Second Preliminary Consultation
MONTGOMERY COUNTY HISTORIC PRESERVATION COMMISSION
STAFF REPORT

Address:	10221 Menlo Ave., Silver Spring	Meeting Date:	8/14/2024
Resource:	1870-1916 Capitol View Park Historic District	Report Date:	8/7/2024
Applicant:	Kenneth A. Gear	Public Notice:	7/31/2024
Review:	Preliminary Consultation	Staff:	Dan Bruechert
Proposal:	Construction of New Single-Family House Construction

1 SITE PLAN
SCALE: 1/8" = 1'-0"

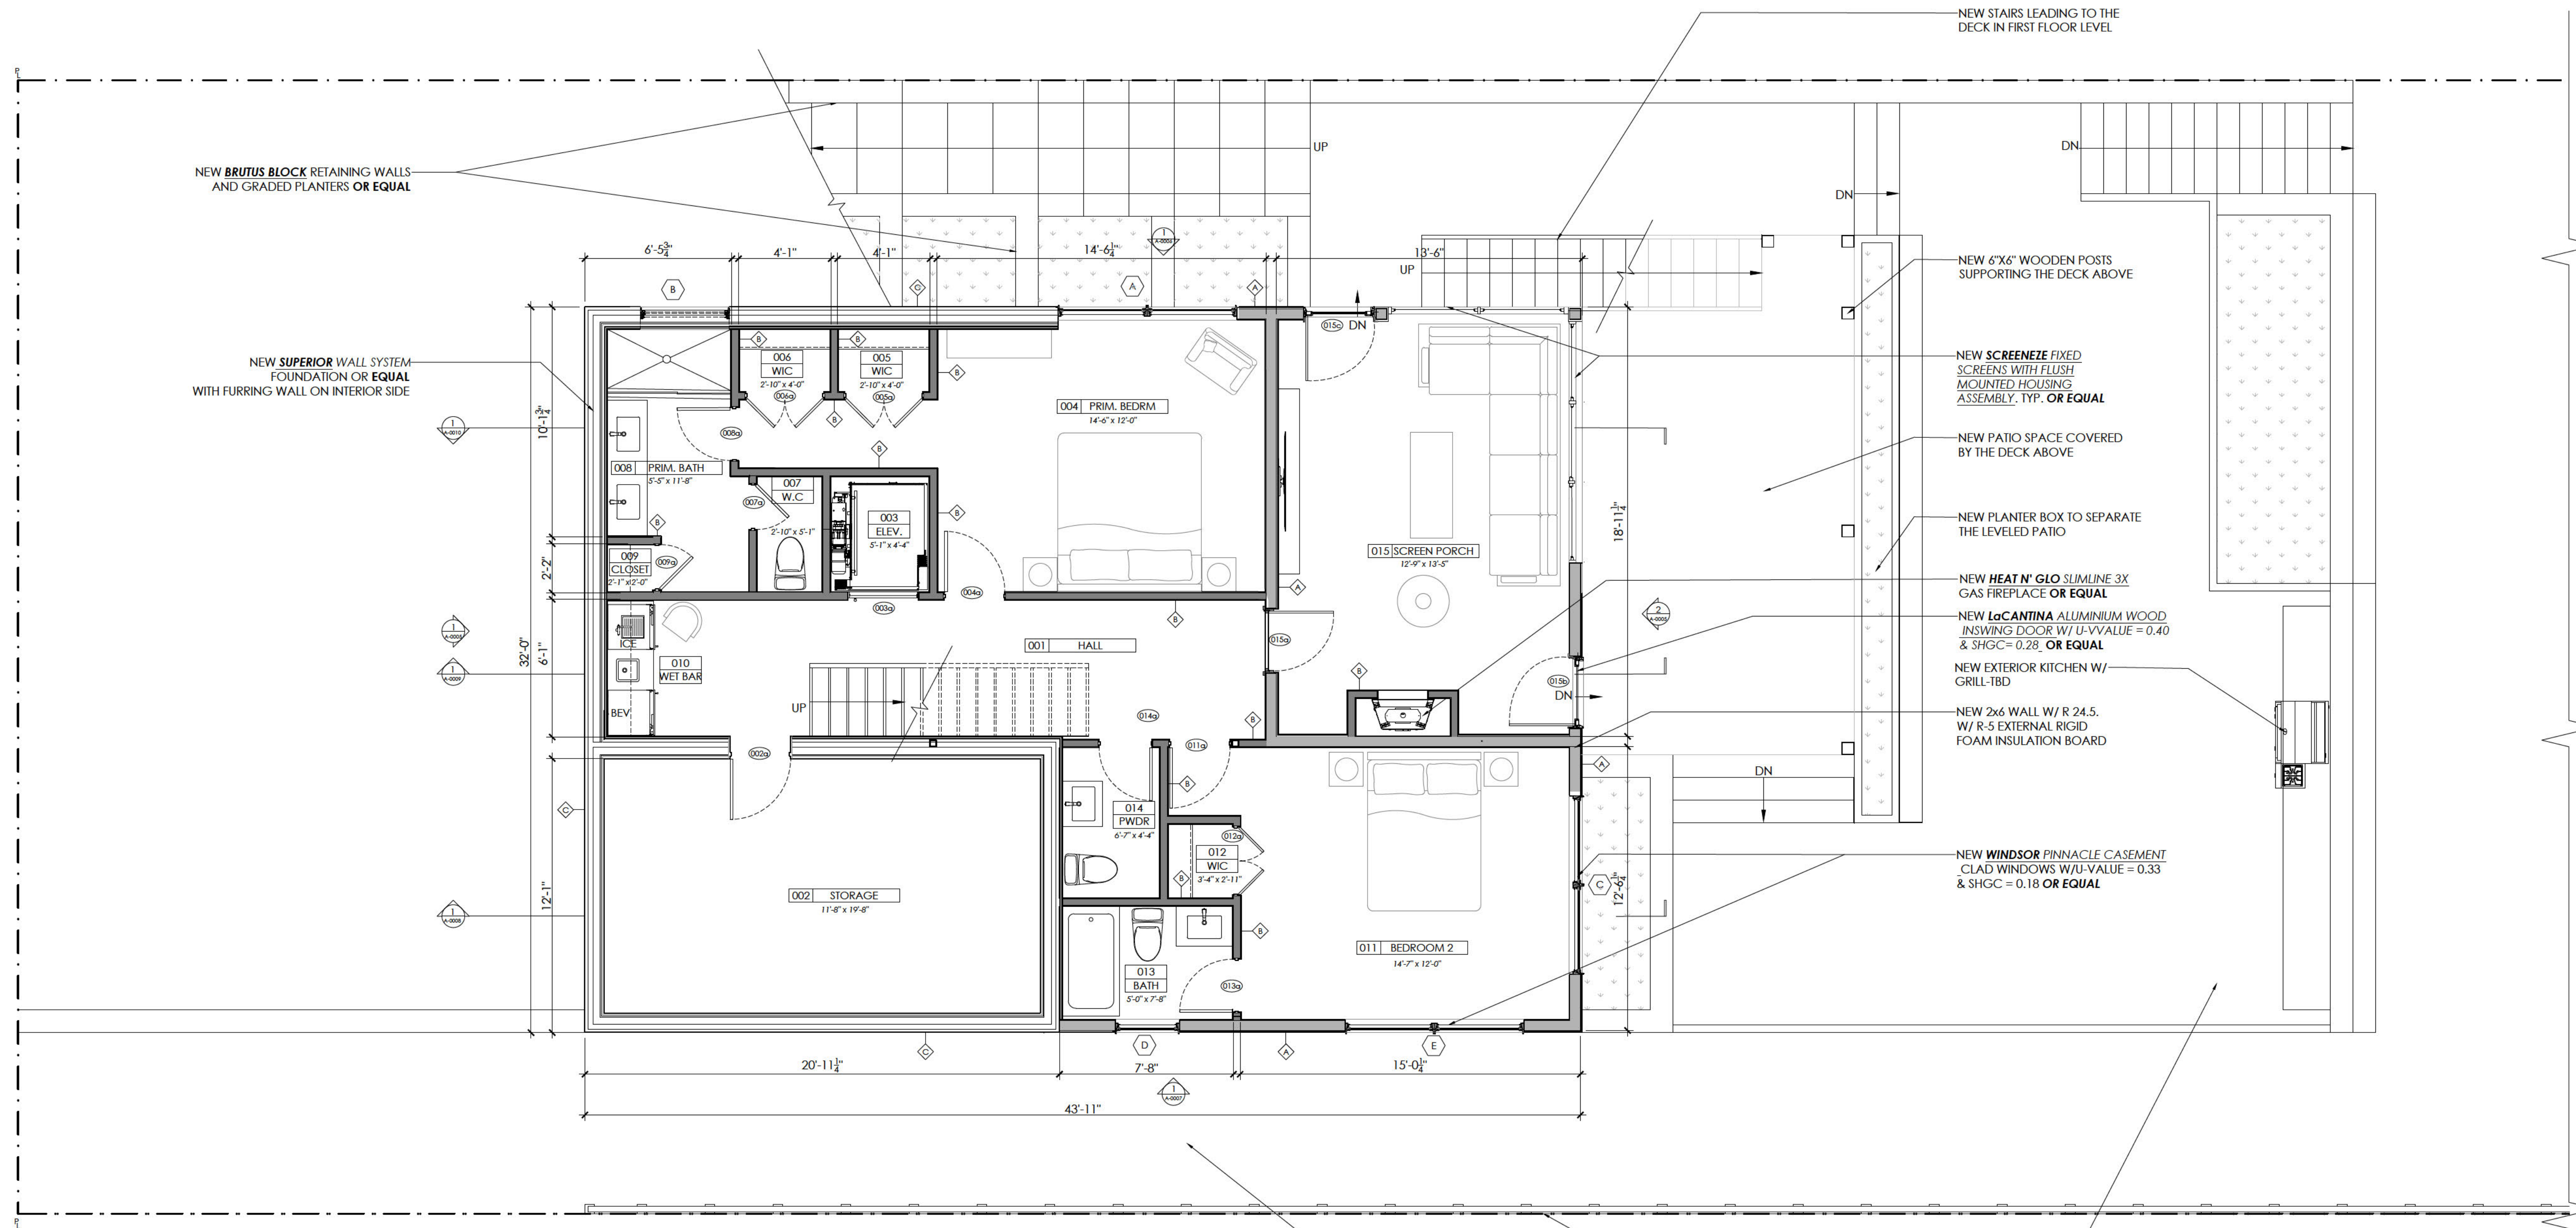
Staff's final considerations are the excavation on site, rear patio, and the front driveway and walkway. The applicant proposes to cut into the hillside to excavate and level the area to accommodate the foundation and rear patio. The applicant states that equalizing the site will eliminate the need for additional fill and will eliminate the need for additional concrete retaining walls. Much of the area between topo lines 370 and 355, shown on the attached topographic survey, will be excavated to accommodate the construction. Staff requests feedback from the HPC on the appropriateness of this excavation and the treatment for the strip to the south of the proposed house.

The driveway will be 25' (twenty-five feet) long and constructed out of stamped concrete. Adjacent to the driveway, the applicant proposes to construct a paved walkway. To the rear of the house, the applicant proposes to construct a patio that measures approximately 35' × 32' (thirty-five feet deep, by thirty-two feet wide), not including the proposed stairs.

Staff finds the stamped concrete driveway will not detract from the character of the district and is modestly sized. Additionally, because parking off street is limited, a walkway to the front door is necessary. No materials were identified for the new walkway, however, the renderings show them constructed using the same concrete as the driveway. Staff would support the driveway and front walk as a HAWP.

Staff finds the proposed patio will not be at all visible from the public right-of-way and, under 24A-8(d), it should be given a lenient review. While no material was identified for the patio, Staff's larger concerns have to do with the size of the patio and the total lot coverage of the proposal. The proposal as presented covers 24.5% of the lot.

Staff requests input from the HPC on the proposed lot coverage and requests recommendations for any site improvements that may minimize the visual impact of the proposed lot coverage if the HPC deems it necessary.

1 WEST ELEVATION
SCALE: 1/4" = 1'-0"

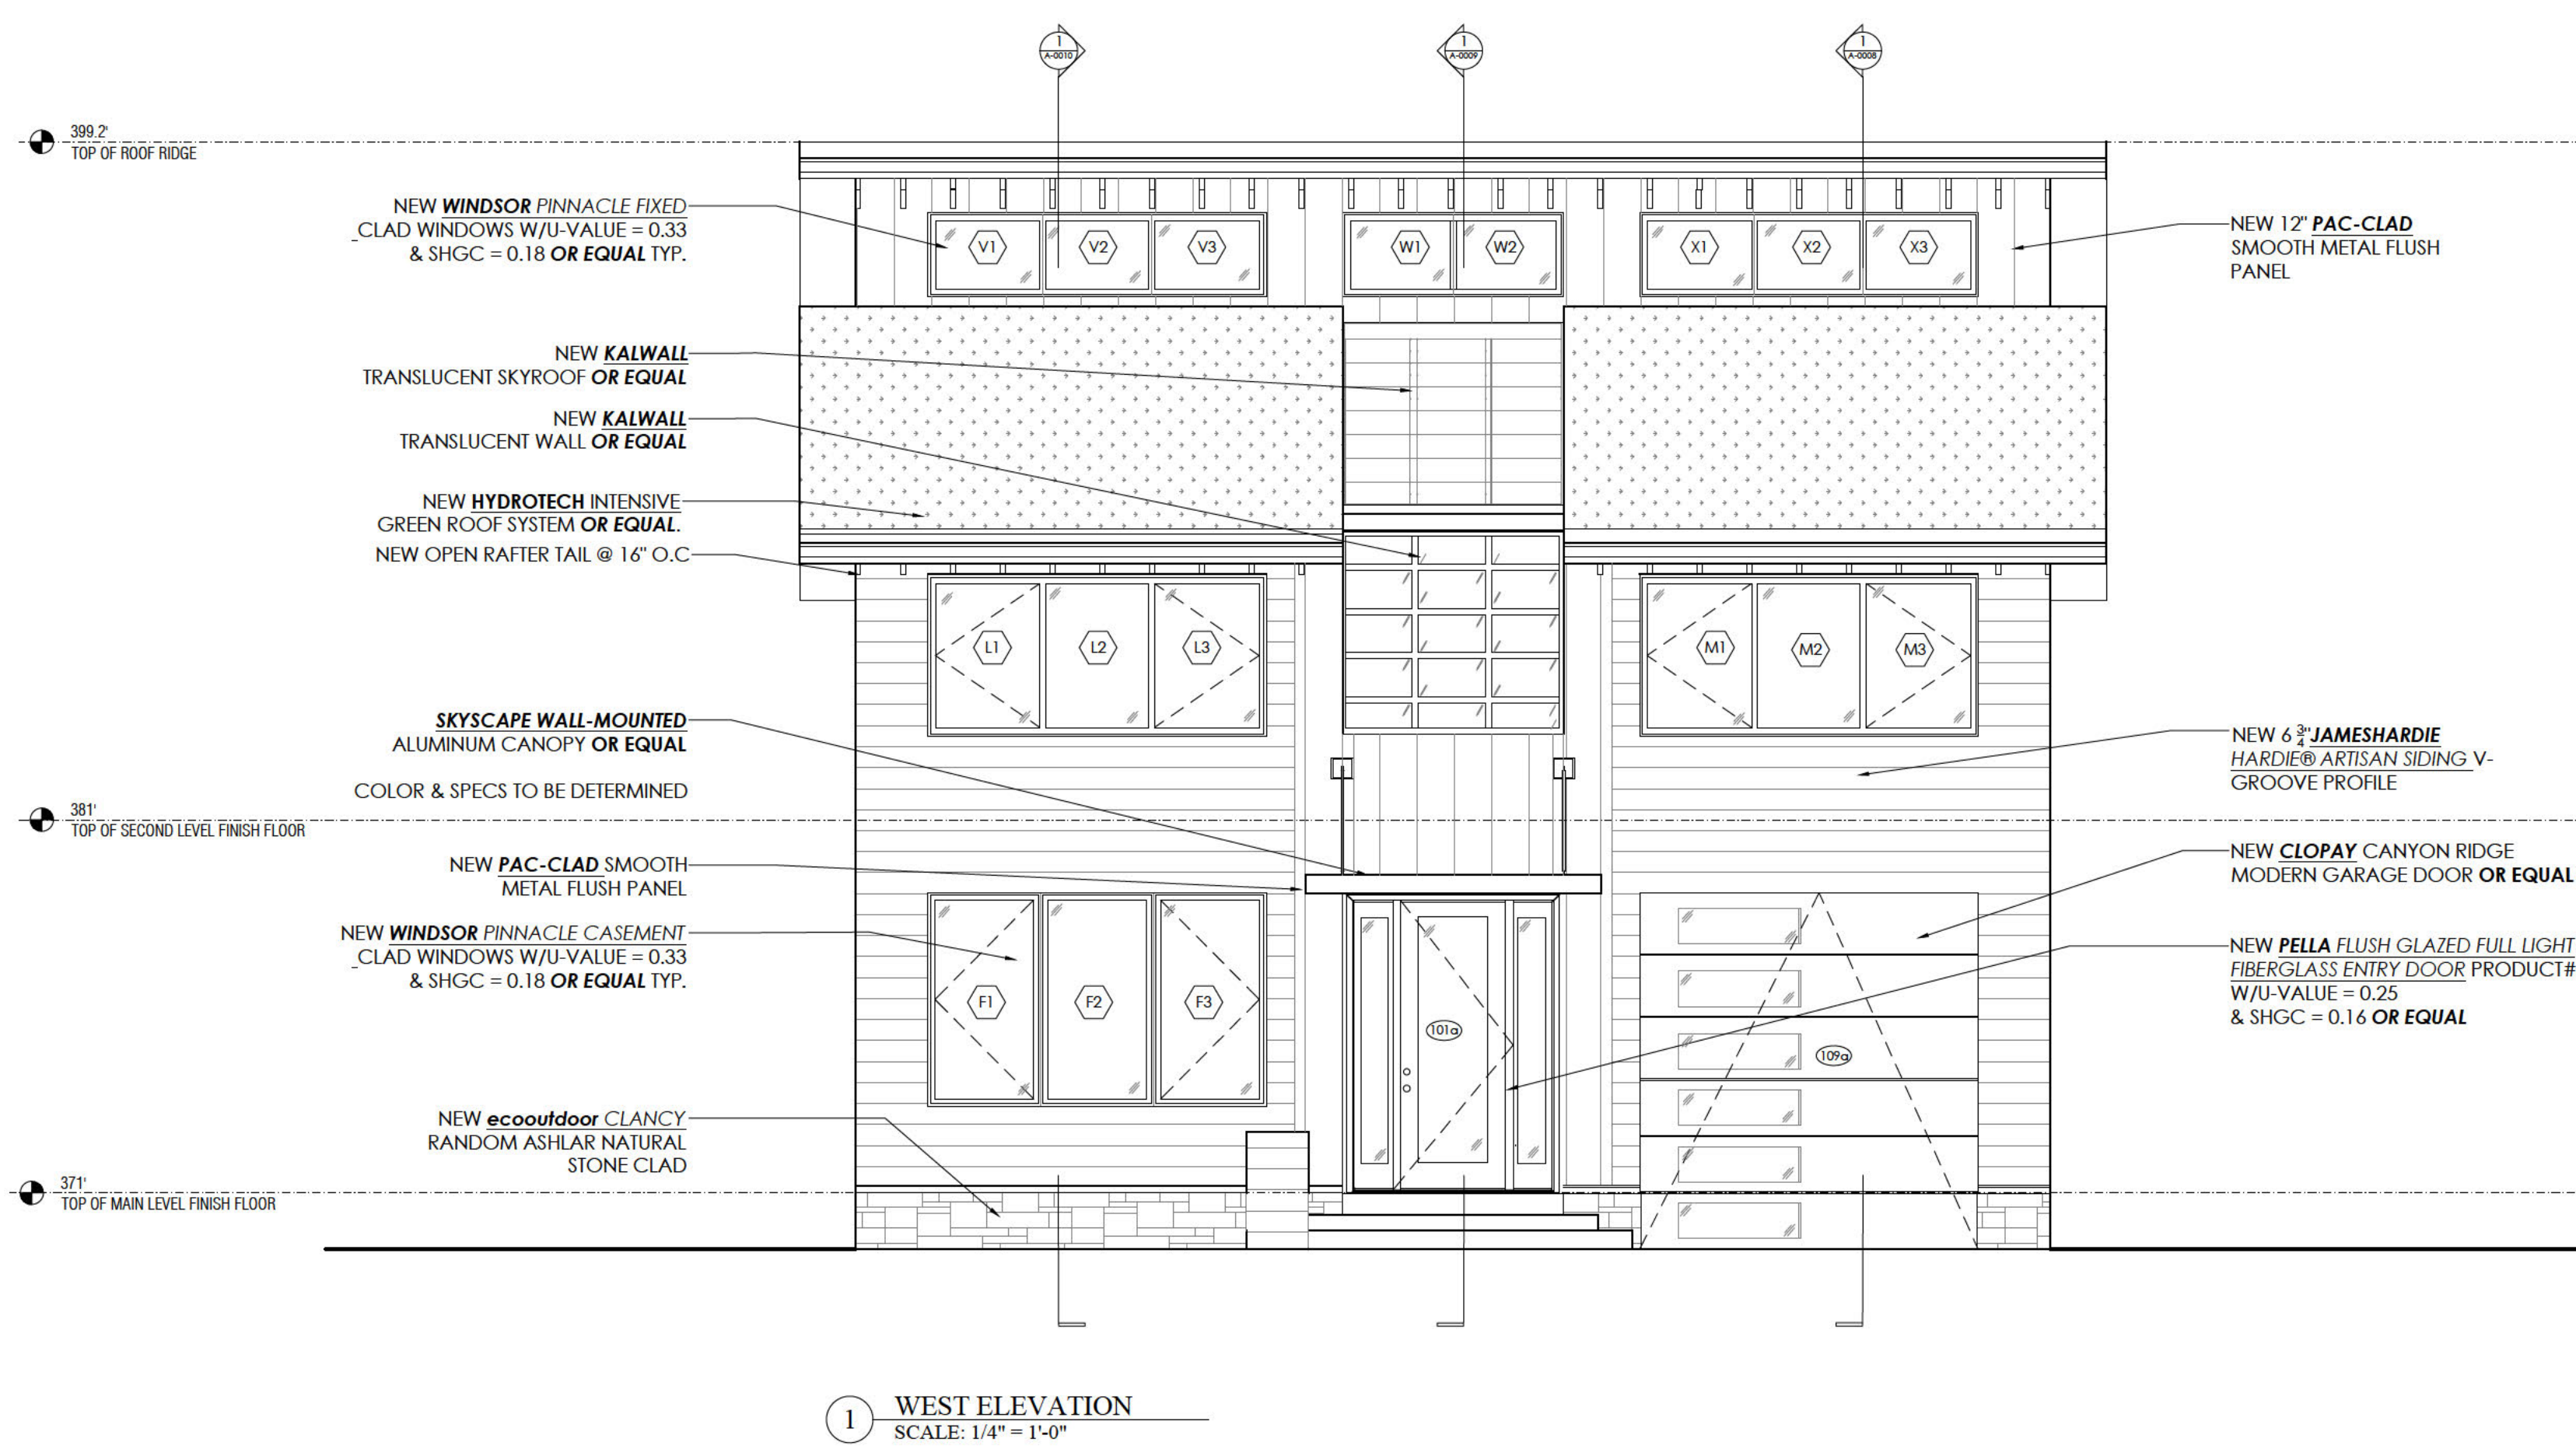
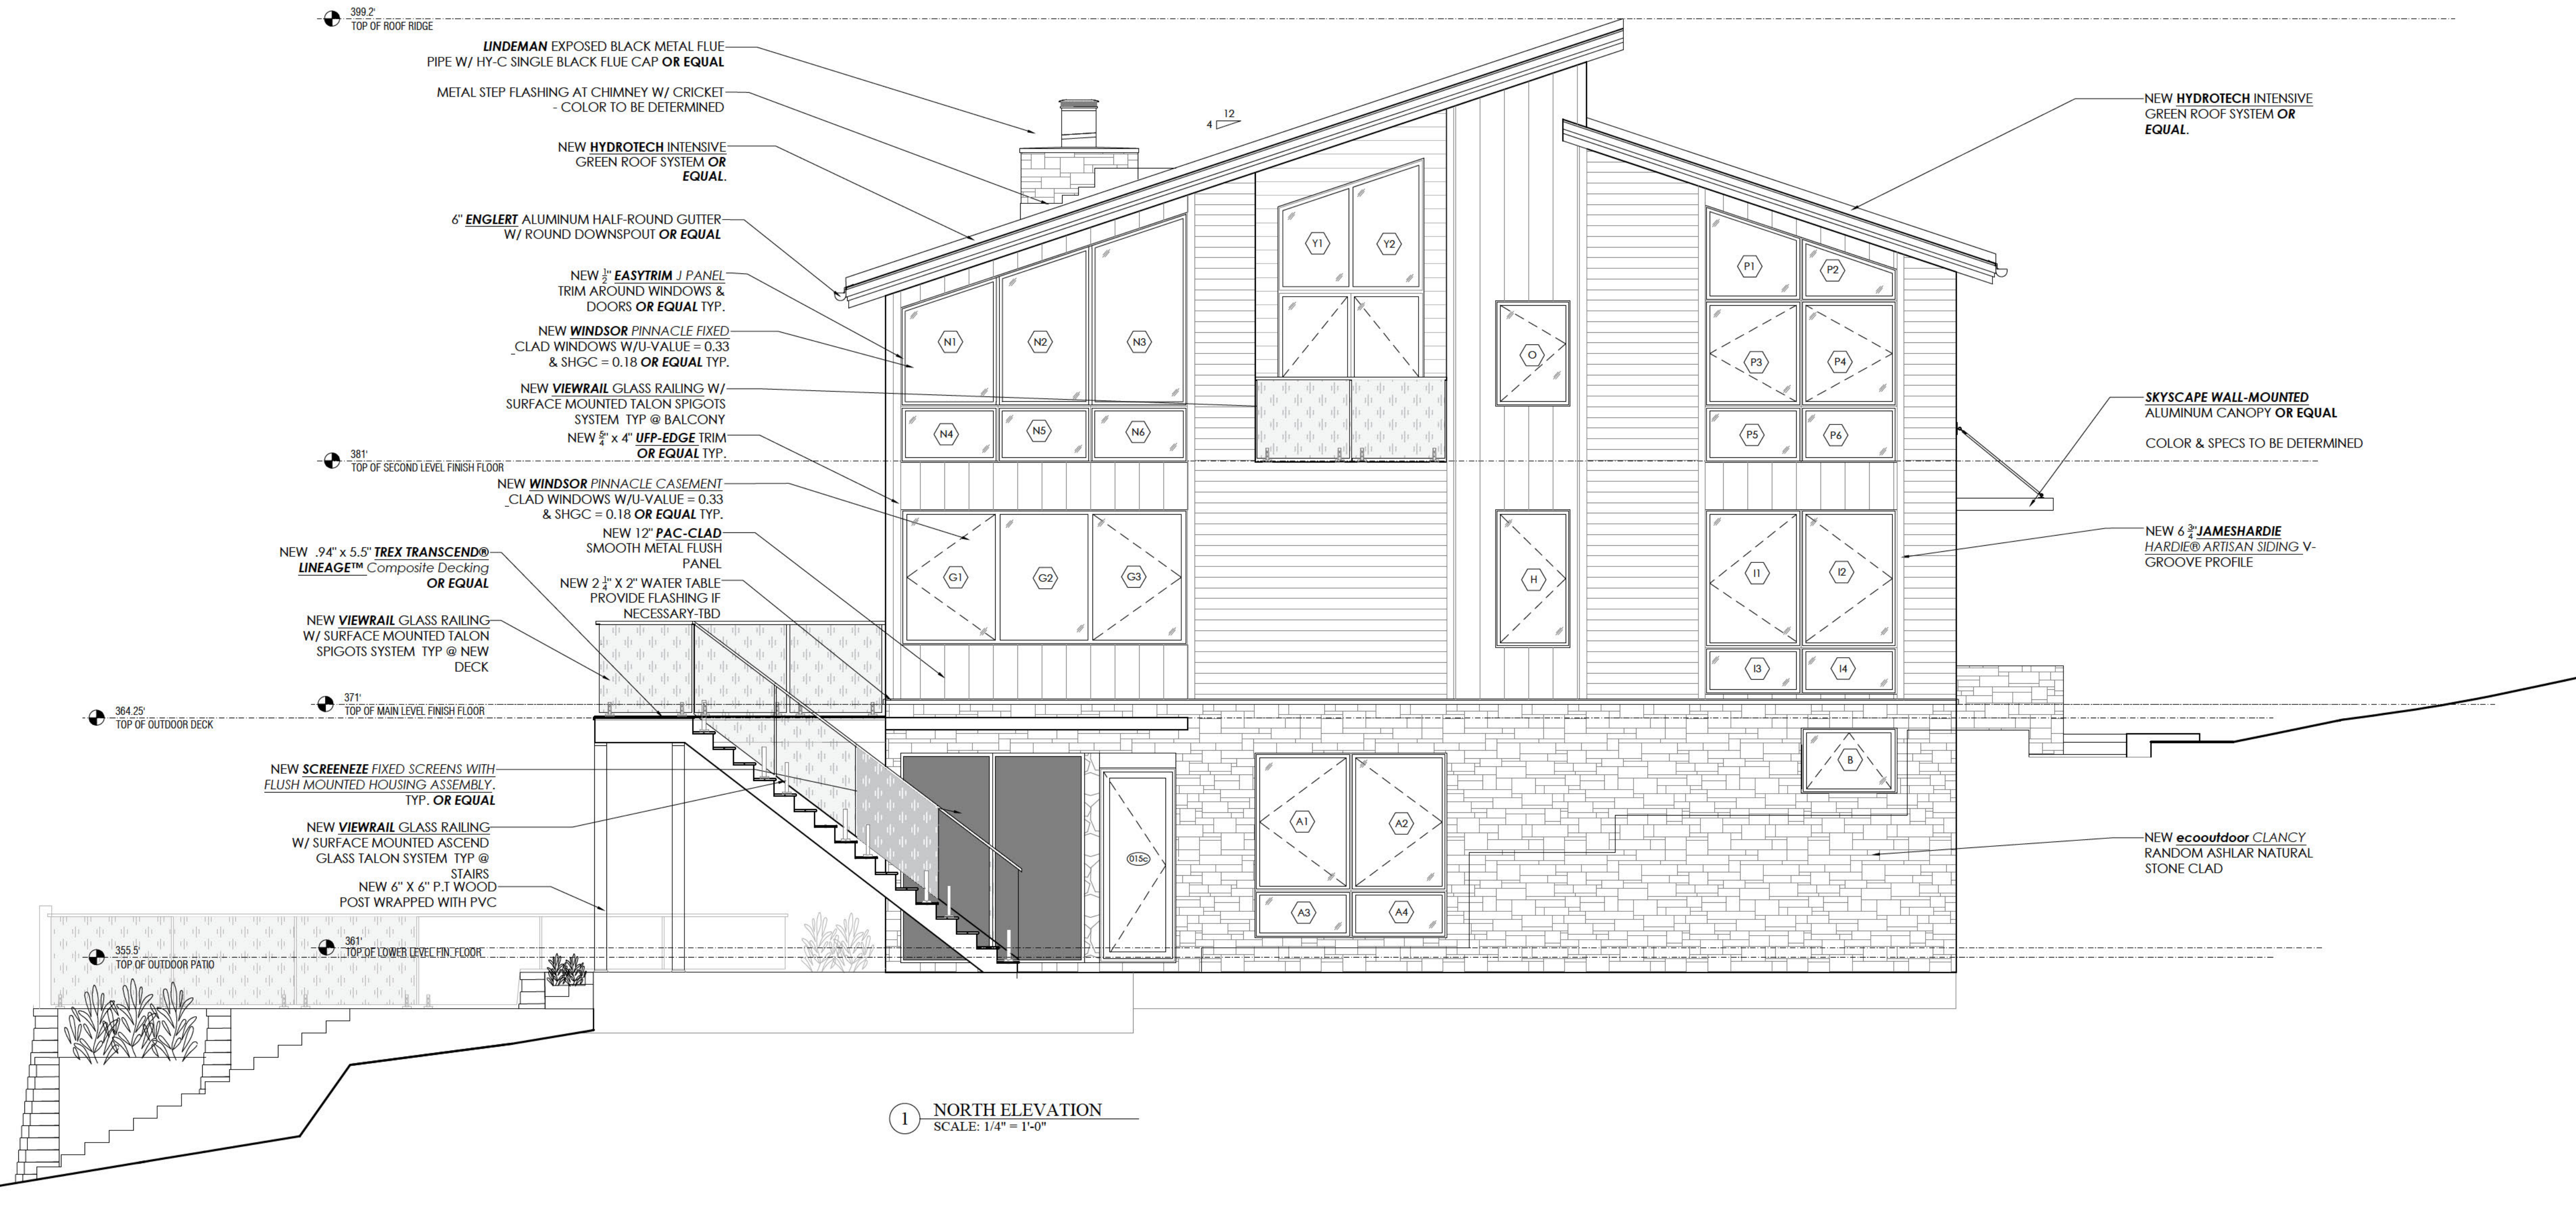
One of the critiques of the design presented at the January 2024 Preliminary Consultation voiced by a number of commissioners, was that the fenestration on the front elevation appeared unbalanced and that the overall fenestration appeared disjointed and hindered creating a cohesive whole. The revised design balances the width of the front elevation opening, and stacks the openings, but Staff notes these are wider openings than are typically found throughout the historic district and creates an appearance with a more highly glazed percentage of wall surface. While Staff also notes that the window openings on the other elevations are stacked, the proposed window sizes are irregular. Staff requests feedback from the HPC on the appropriateness of the fenestration size and arrangement.
